SSPD8 - ENGINE TEMPERATURE AND HEATER PERFORMANCE CONCERNS WITH OR WITHOUT DTC P0126:00

Updated 3/4/2026:

WARRANTY EXTENSION

REPAIR PROCEDURE – FLOW CHART

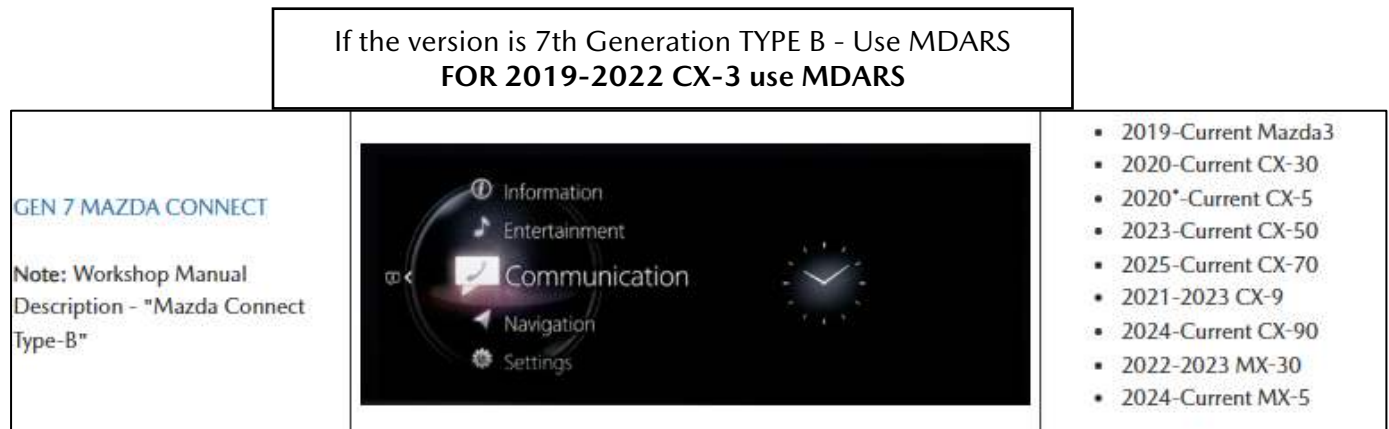
Section A: Flow Chart: **NOTE: This Flow Chart needs to be followed strictly.**

The dummy plug and PCM update repair procedure are required as of December 8, 2025. The TSB has been updated to repair with the dummy plug and PCM update here: [6](#).
